**ADDENDUM NO. 2 – DPW#17603 – Southeast Idaho Veterans Cemetery**

**Project:** DPW#17603 Southeast Idaho Veterans Cemetery  
Blackfoot, Idaho

**DPW Project No:** 17603  
**VCGP Project No:** FAI ID-13-03

### Architectural Addendum No 02

DETAIL: PER VA PROGRAM AND ADD ALTERNATE #02 – RECEPTION DESK

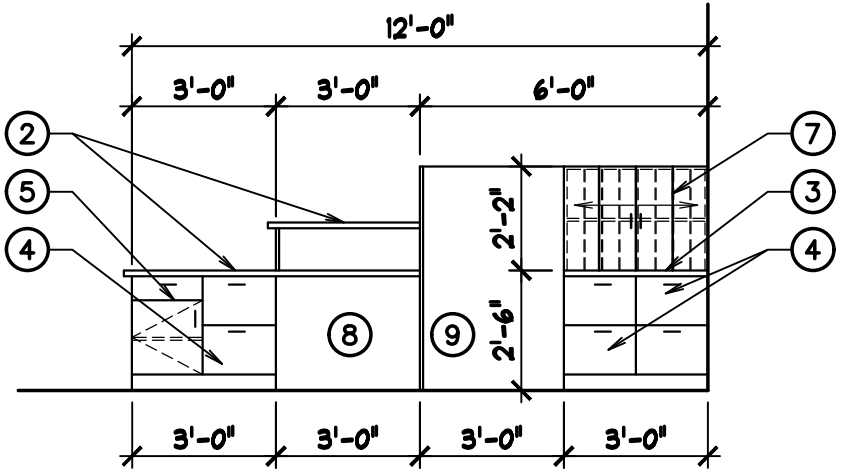
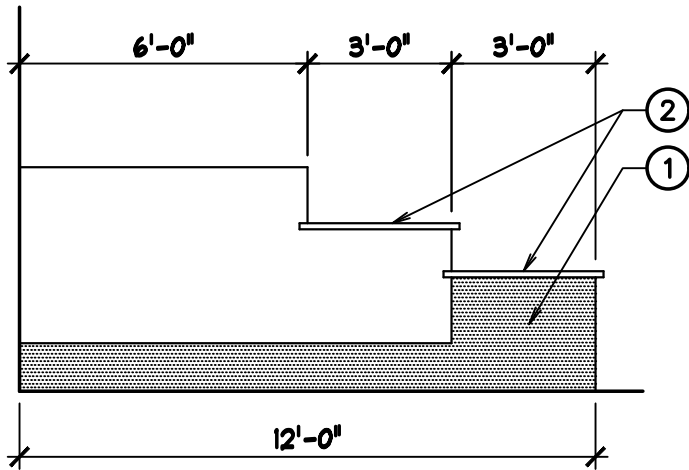
AD2.0 Administration Building: Per VA Program and Add Alternate #02 - Reception Desk

DETAIL: PER VA PROGRAM ADMIN BLG  
PARTIAL CEILING PLAN

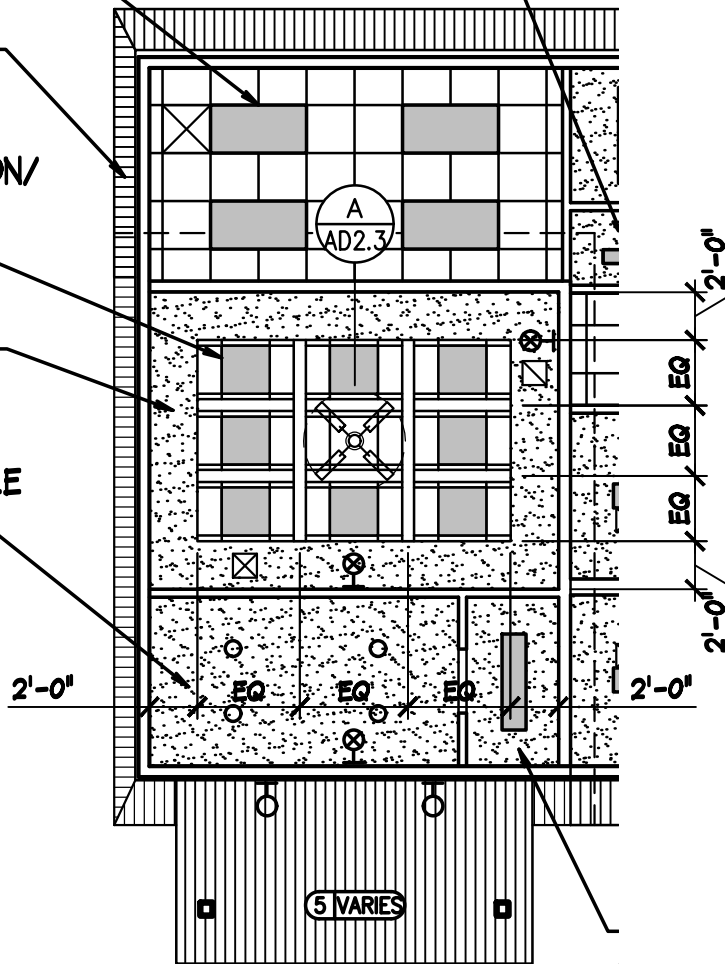
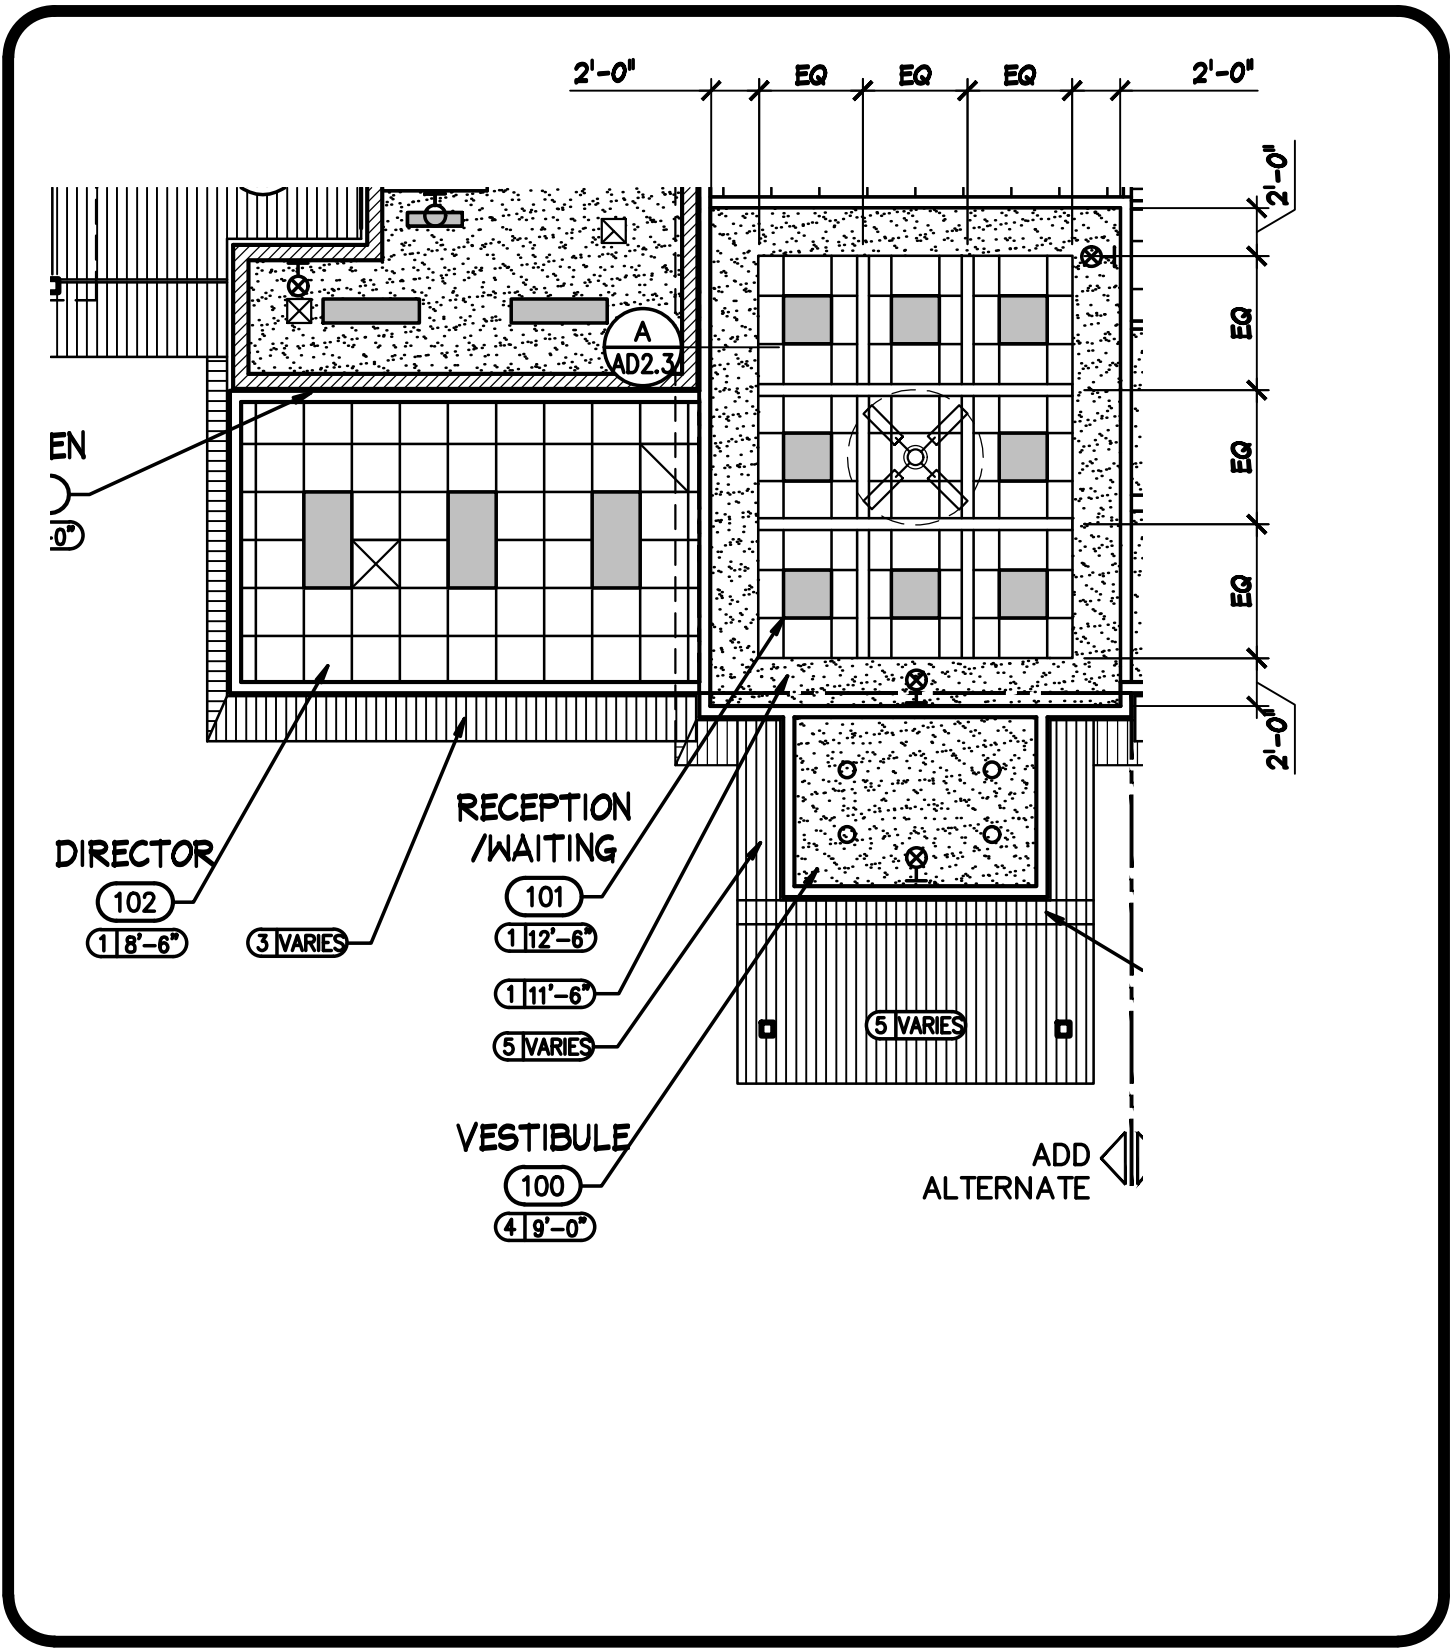
AD2.1 Administration Building: Per VA Program - Partial Ceiling Plan

New ceiling layout.

Raise ceiling in Director's Office 102 to 8'-6".

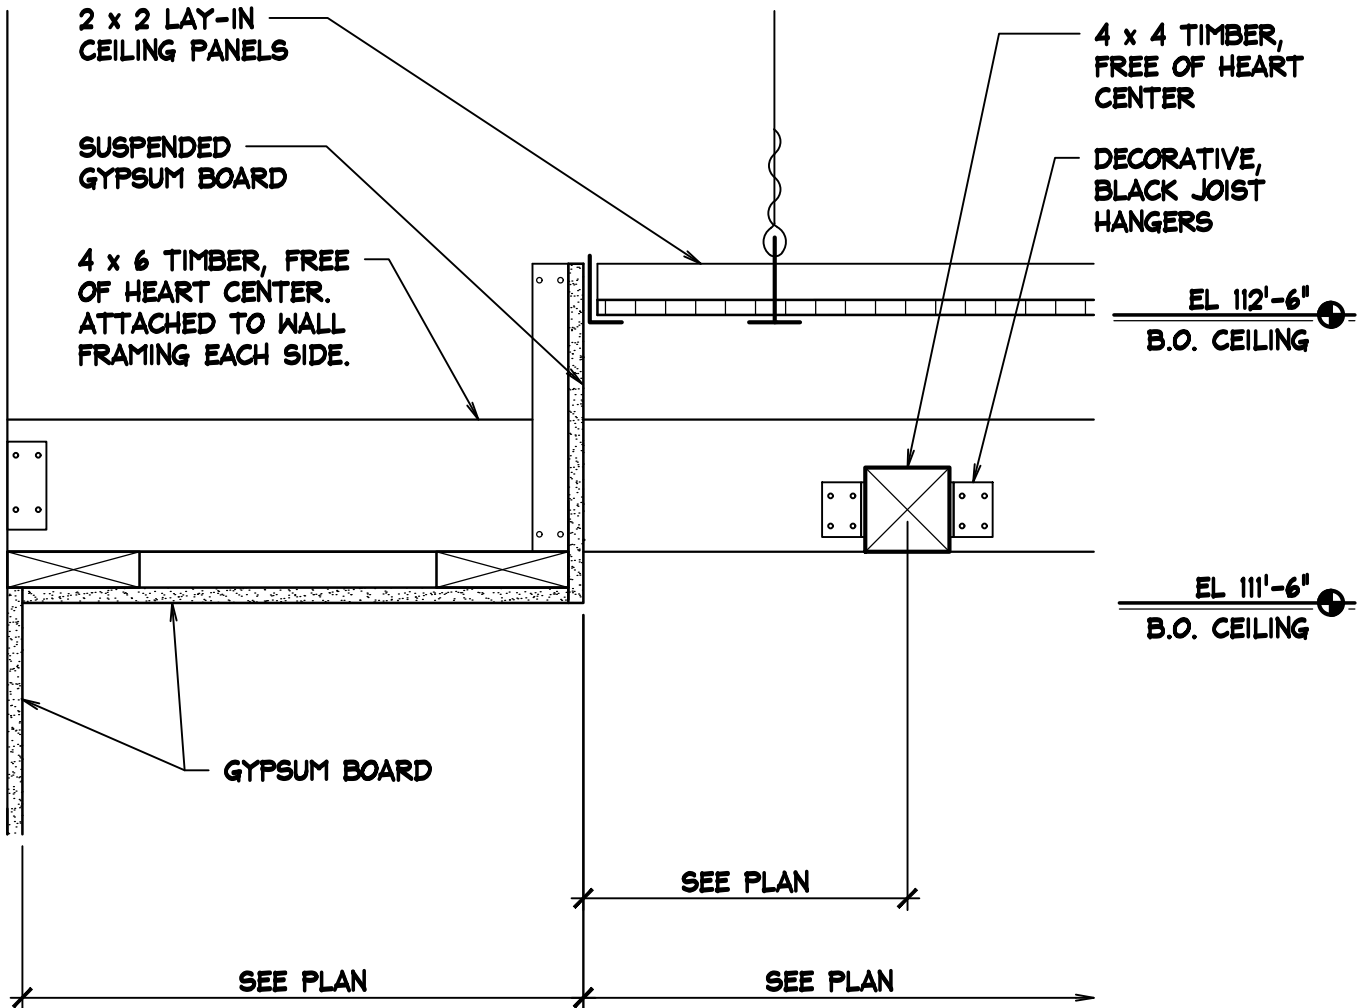
AD2.2 Administration Building: Add Alternate #02 – Partial Ceiling Plan

New ceiling layout.

Raise ceiling in Director's Office 102 to 8'-6".

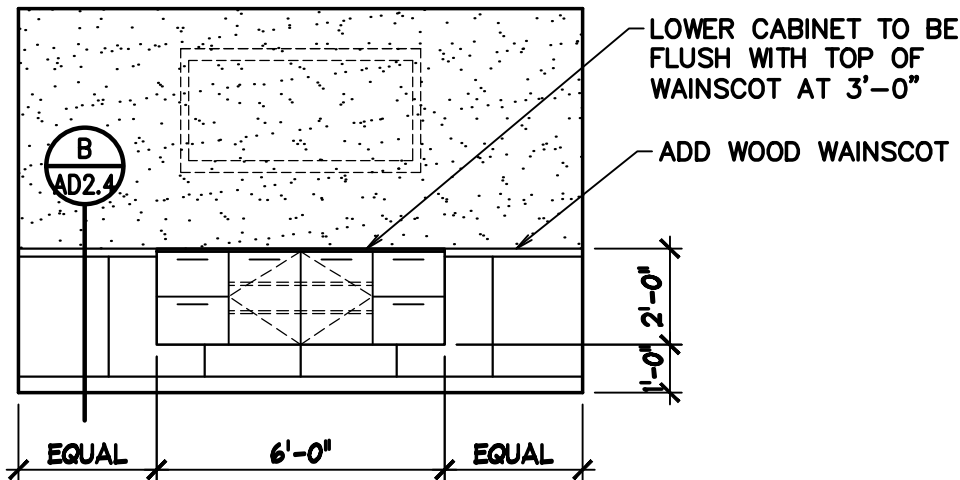
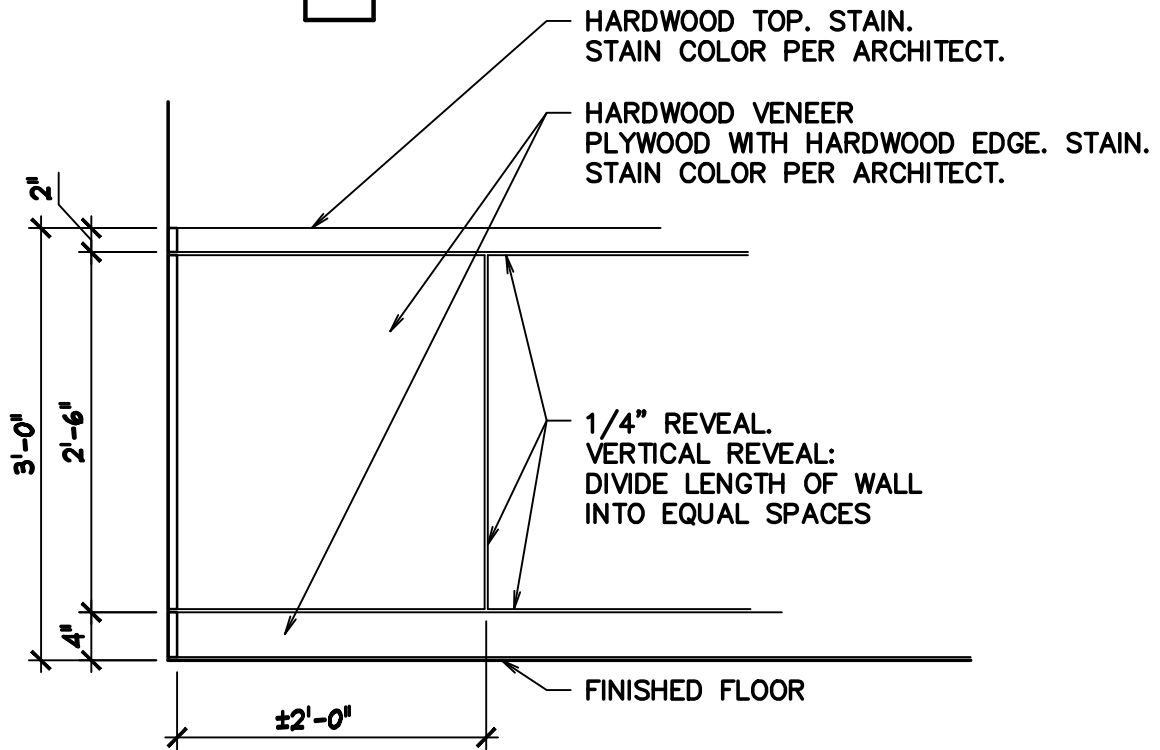
AD2.3 Administration Building: VA Program and Add Alternate #02 - Ceiling Detail

DETAIL: PER VA PROGRAM AND ADD  
ALTERNATE #02 - DIRECTOR'S OFFICE

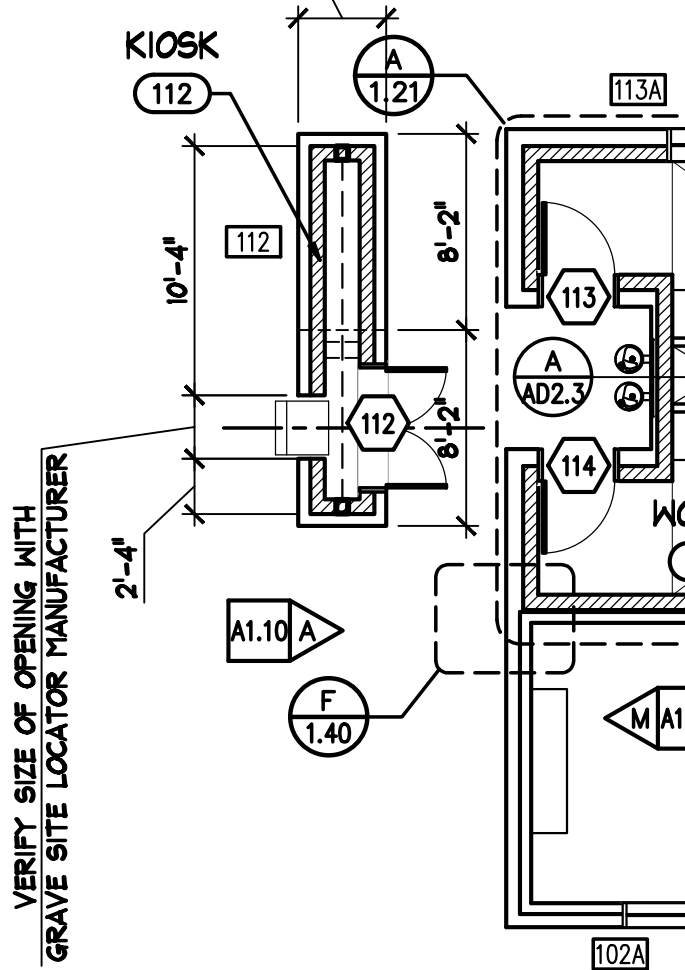
AD2.4 Per Administration Building: VA Program and Add Alternate – Director's Office 102

Add wainscot to all (4) walls. Delete rubber base.

Elevation M/A1.20: top of cabinet to be at 3'-0".

VA Program only: Add cabinet to Director's Office 102.

DETAIL: ADD ALTERNATE #02 – PARTIAL FLOOR PLAN

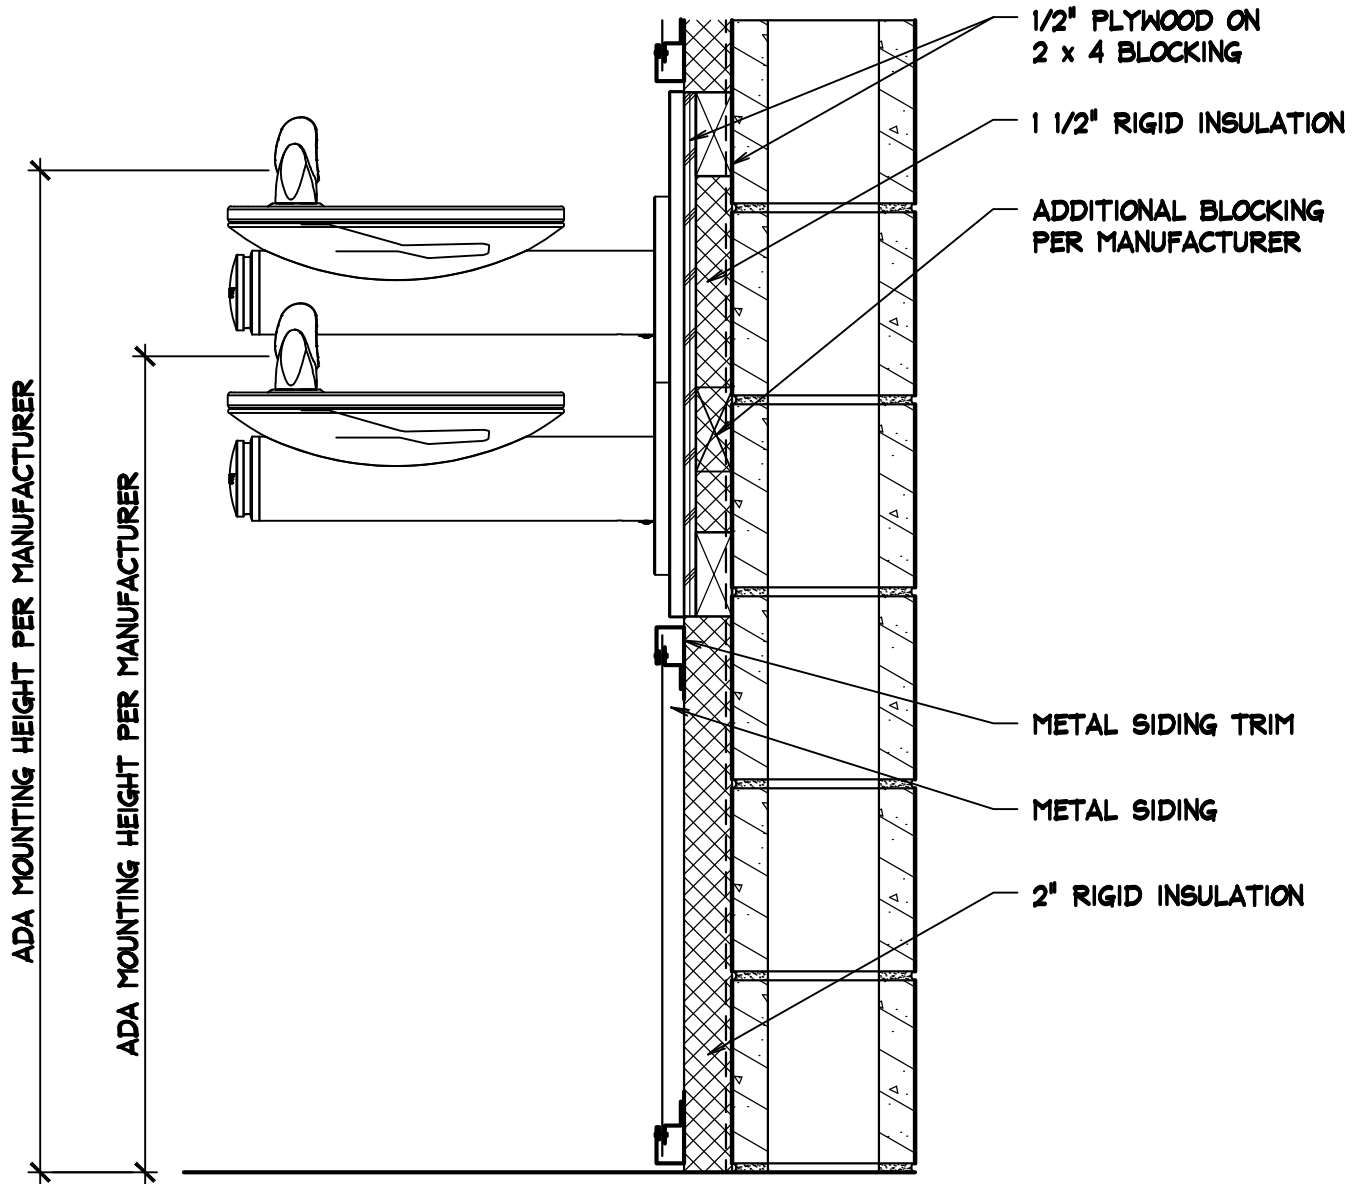
AD2.5 Administration Building: Add Alternate #02 – Partial Floor Plan

Change door 112 to a 5'-0" double door.

Location of opening for grave site locator has been edited.

Delete all references to size of opening for grave site locator contained in Section A /A1.40, Detail C/A1.40 and D/A1.40. The size of the opening for the grave site locator should be verified with grave site locator manufacturer.

New Hardware group for door 112:

#### HARDWARE GROUP NO. 10

For use on Door #(s):

A112

Provide for DBL door(s) with the following:

6	EA	HINGE	5BB1 4.5 X 4.5 NRP	630	IVE
1	EA	MANUAL FLUSH BOLT	FB458 (TOP)	626	IVE
1	EA	STOREROOM LOCK	T581P6 DANE	626	FAL
1	EA	SECURITY ASTAGAL	43SP (PULL SIDE ACTIVE LEAF)	600	ZER
2	EA	WALL STOP	WS606/407 CCV	630	IVE
2	EA	KICK PLATE	8400 10" X 2" LDW B-CS	630	IVE
2	EA	GASKETING	429AA-S	AA	ZER
2	EA	RAIN DRIP	142AA	AA	ZER
2	EA	DOOR SWEEP	39A	A	ZER
1	EA	THRESHOLD	655A-223	A	ZER
